Lower Lee (Cork City) Flood Relief Scheme

**Exhibition Report
Non-Technical Summary**

Modelling of navigational impact of Little Island barrier proposed by stakeholder group

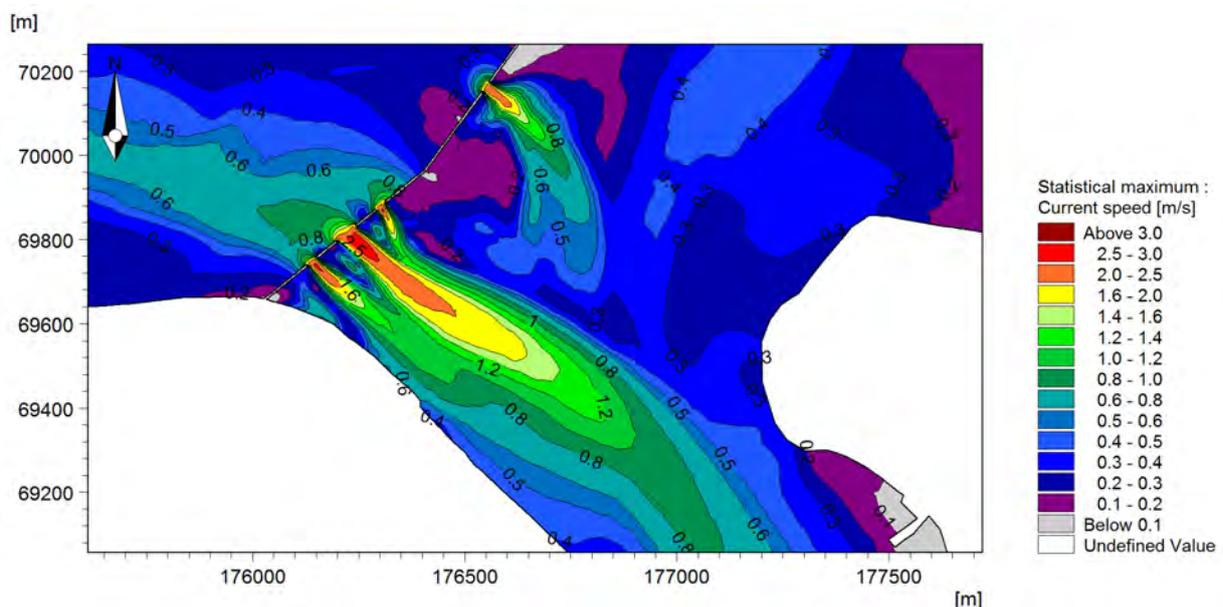
- Any tidal barrier would need to be located downstream of Lough Mahon to have sufficient storage to cater for inflow from the Lee during periods of closure.
- **Little Island:**
The furthest upstream location for a potential barrier is at Little Island. However, this location presents particular problems as follows:

Environmental: Its immediate proximity to environmentally designated sites means that achieving the necessary statutory consents would be challenging and time consuming and would likely require very large 'gates' to minimise impacts on the existing regime.

Navigation and Navigational Safety: Such large gated area would also be required to meet acceptable navigational safety requirements.

Cost: A technically viable barrier at this location is estimated to cost almost €1bn, which is not economically viable.

Climate Change: Furthermore, this location does not have sufficient upstream storage to cater for the likely future climate change scenarios and thus is unlikely to represent the optimum long-term solution for Cork.

A tidal barrier either side of Great Island
Schematic image showing a potential tidal barrier at Monkstown

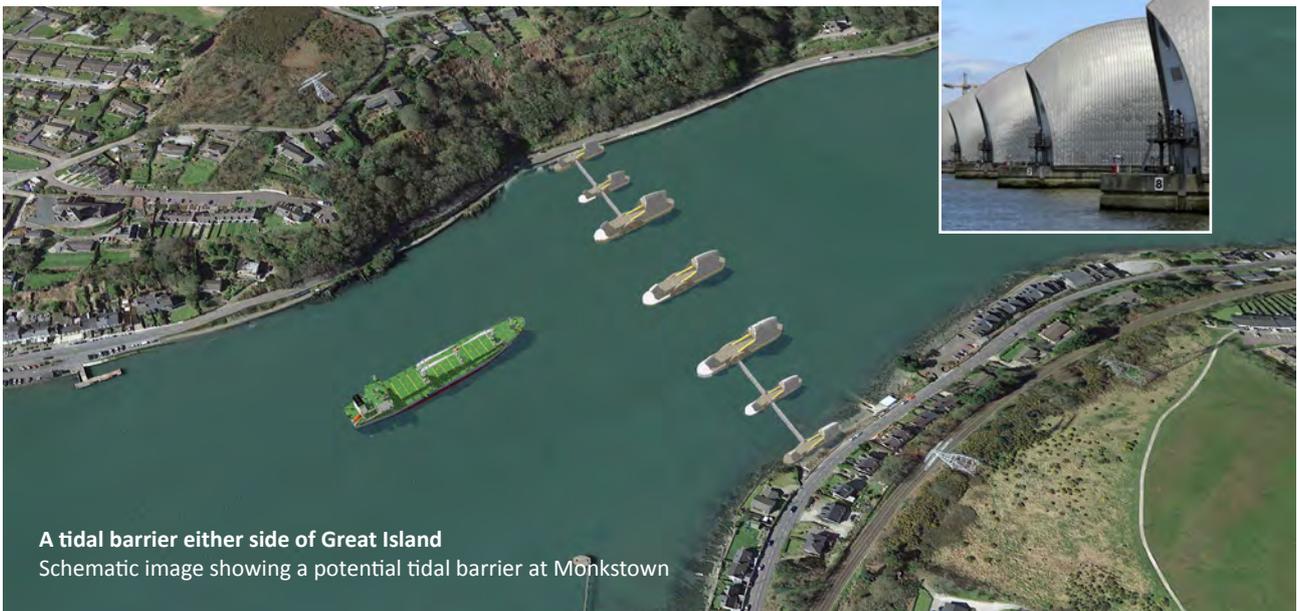
A tidal barrier either side of Great Island has sufficient upstream storage to cater for sea level rise of 1m or more, as well as increases of 30% or more in river flows. Technically, it therefore represents a better long-term solution in the face of climate change and also has the benefit of protecting a greater area of the harbour including Midleton, Passage West, etc.

To maintain continued safe navigation, and minimise environmental impacts, a barrier at Great Island would need to be gated across the full width of the existing channel at East and West Passage. This option is technically feasible but has an estimated cost in excess of €1.7bn.
